January 28, 2014

RE: Project #606376 Cambridge Street bridge over I-90, Allston, Boston

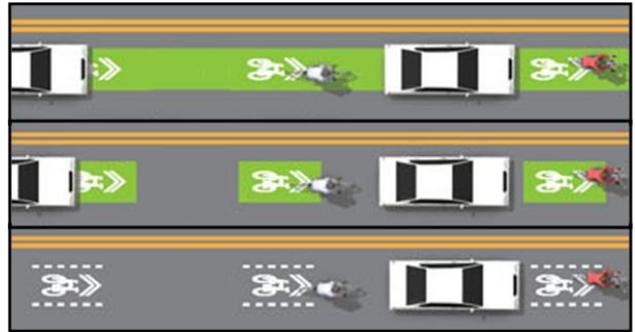
We thank MassDOT for agreeing to remove the median fence on the northeast end of the project scope. It would be a great enhancement to plant trees and other plants in this median instead of a concrete or asphalt strip. A model for this could be Commonwealth Ave near the BU Bridge where there is a row of trees planted with 20' spacing in a 4' median. We have requested, through the City Council and Mayor's office, that the City provide the needed support and ongoing maintenance for these plantings.

If adding irrigation is not feasible, stormwater tree pit design should be used so that runoff from the street is diverted into the planting area where stormwater is absorbed and associated pollutants are filtered. Storage chambers below the planting area can hold additional runoff for plant uptake or groundwater recharge.
